PREVOST

**WARRANTY
BULLETIN**

WB13-58

DATE :	OCTOBER 2013	SECTION :	01 - Engine
EXPIRATION:	OCTOBER 2015		
SUBJECT :	AIR INTAKE HOSE REPLACEMENT

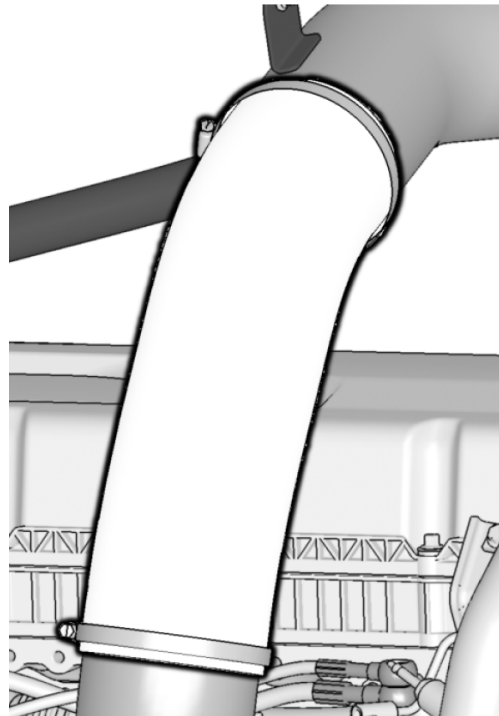
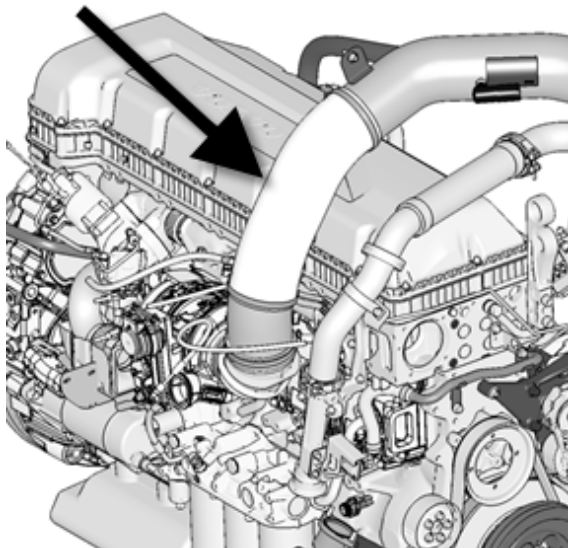
1. On the engine, locate this air intake flexible hose on the left side of the engine.

2. Remove the clamps and hose
3. Install a clean cap on engine air intake to protect from dust and debris.
4. Replace by new hose #033195 and #504786 clamps.

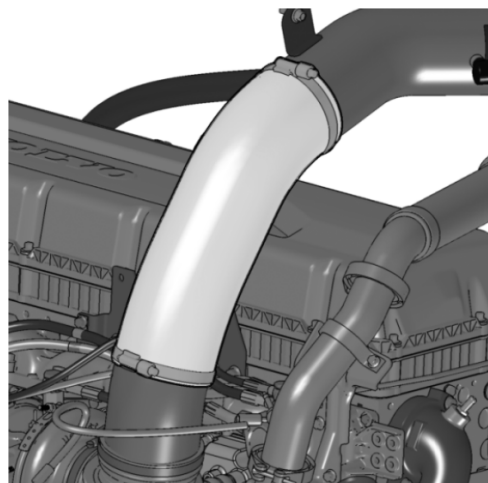
Attach lower clamp to support provided in this area.

5. Pay particular attention to the tail of the clamp to make sure it does not touch any hoses in the surrounding area.

Re-orient or shorten the tail if required.
